RECEIVED
OCD-HOBBS
SUNDY NOTICES AND REPORTS ON WELLS
Do not use this form for proposals to drill or to re-enter an abandoned well. Use form 3160-3 (APD) for such proposals.

Mallon 35 Fed No. 1

☒ Other Convert to SWD

**Mallon 35 Federal 1
30-015-32983
Cimarex Co of Colorado
June 11, 2010
Conditions of Approval**

Proposed New Perforations

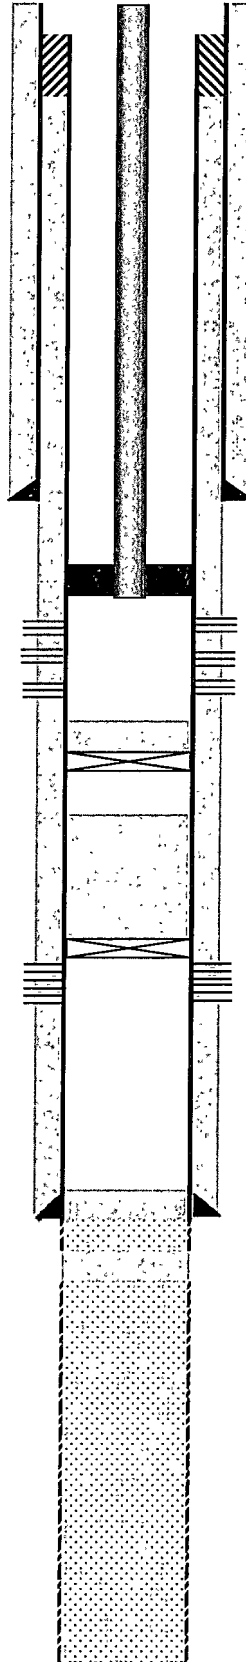
- Propose to add additional Class C cement on existing CIBP for a minimum of 50' above top of Delaware @ 5606.'
- Will add CIBP @ 4600' w/ 35' Class C cement to satisfy OCD requirement of cement within 200' of bottom injection perf.
- Cimarex proposes to add Seven Rivers perfs at 3932' - 4404' and convert well to a SWD. See attached current and proposed WBD's.

- 1. Tag existing cement on CIBP prior to adding cement.**
- 2. Surface disturbance beyond the existing pad must have prior approval.**
- 3. Closed loop system required.**
- 4. Operator to have H2S monitoring equipment on location as H2S has been reported from surrounding wells.**
- 5. A minimum of a 2M BOP is required and must be tested prior to performing operations.**
- 6. Subsequent sundry with wellbore schematic and completion report required.**
